ACCESSION NBR: 8308110149 DOC. DATE: 83/08/05 NOTARIZED: NO DOCKET #
 FACIL: 50-220 Nine Mile Point Nuclear Station, Unit 1, Niagara Powe 05000220
 AUTH. NAME AUTHOR AFFILIATION
 MANGAN, C.V. Niagara Mohawk Power Corp.
 RECIP. NAME RECIPIENT AFFILIATION
 VASSALLO, D.B. Operating Reactors Branch 2

SUBJECT: Forwards response to 830726 request for addl info re
 proposed expansion of spent fuel pool. Cask drop protection
 sys within pool consists of dashpot supported vertically by
 pool floor.

NRC REQUEST FOR ADDITIONAL INFORMATION
NINE MILE POINT SPENT FUEL POOL
EXPANSION - STRUCTURAL ASPECTS

BY D. P. ... DATE 7/27/83 SUBJECT NMPL-IT SHEET NO. 2 OF
CHKD. BY DATE QUEST 14 PROJ. NO. 8202

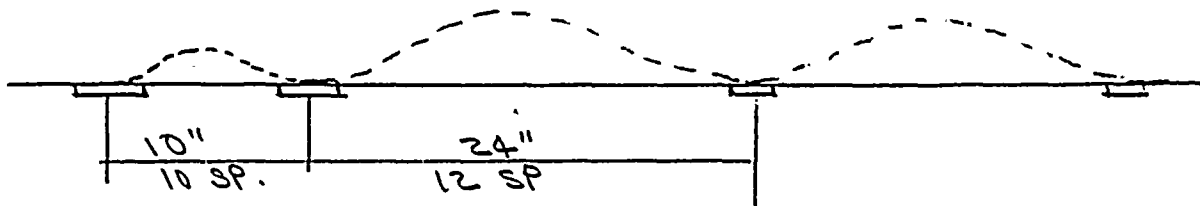
RESPONSE TO QUESTION BROUGHT UP BY
NRC IN JULY 25, 1983 MEETING TO ADDRESS
LINER STRESSES DUE TO BOTH GLOBAL
LOADING: (FROM POOL ANALYSIS) AND LOCAL
LOADING: (FROM RACKS) - CALL THIS QUESTION #14

BUT THE LINER IS A FLEXIBLE ELEMENT
IN COMPRESSION & CAN THEREFORE BUCKLE.
BUCKLING IN THIS INSTANCE DOES NOT CONSTITUTE
"FAILURE" SINCE THE LINER IS NOT A STRUCTURAL
LOAD CARRYING ELEMENT.

THE LINER IS A 1/4" THICK PLATE WHICH IS
WELDED TO 5" X 3/4" PLATES RUNNING N-S IN
THE POOL, WHICH ARE IN TURN ATTACHED TO
THE POOL FLOOR CONCRETE SLAB BY 5/8" - ϕ
ANCHOR BOLTS.

IN THE $E-W$ DIRECTION THE MIN LINEAR SPAN IS $10\frac{1}{2}$ " & MAX IS $24\frac{9}{16}$ " WITH AN AVERAGE OR $23\frac{13}{16}$ ". SINCE THE PLATE IS BACKED UP BY CONCRETE, IT WILL BUCKLE IN THE FOLLOWING CONFIGURATION:

BY D. Smith DATE 1/27/63 SUBJECT NMP1-JT SHEET NO. 3 OF
CHKD. BY DATE QUEST 14 PROJ. NO. 8202

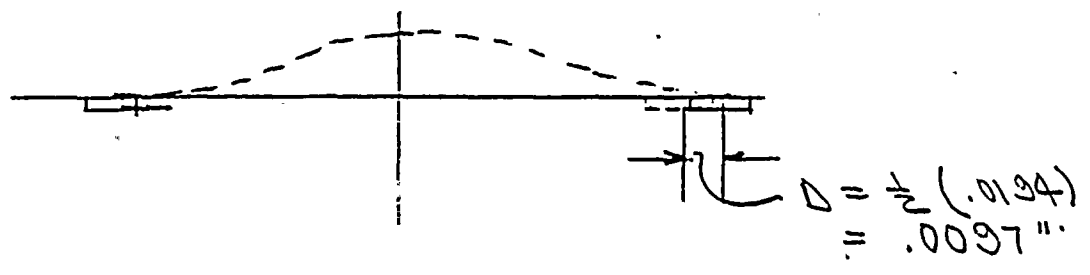
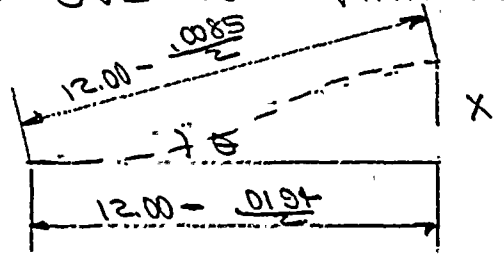
\therefore THE 24" SPANS WILL BUCKLE PRIOR REACHING THE FULL COMPRESSIVE STRESS OF 32,700 PSI. HOWEVER THE DISTANCE BETWEEN CHANNELS MUST STILL BE REDUCED BY $\epsilon L = .0008(24) = -.0194 \text{ IN.}$

THIS DIFFERENCE ACCOUNTED FOR BY
BUCKLED SHAPE:

THIS DUE TO "TRIANGULATION" OF DEFLECTED R:

$$X = 11.990 (.03015) = 0.362 \text{ IN.}$$

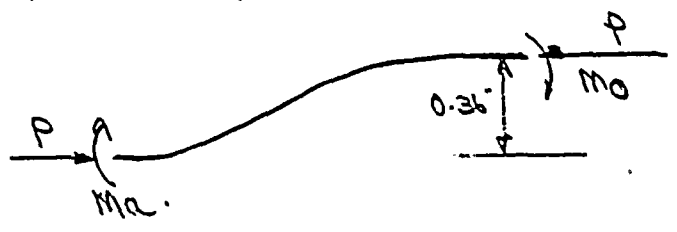
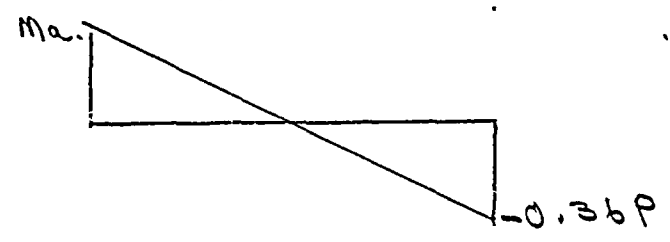
ASSUME BUCKLED SHAPE IS IDENTICAL TO
DEFLECTED SHAPE OF A BEAM LOADED BY A
COMPRESSIVE LOAD & MOMENT EQUAL TO
 $P Y$ WHERE Y IS DEFLECTION.

$$M_0 = M_a - P Y$$

FOR 4" WIDE SECTION:
 $M_0 = M_a - 9950 Y.$
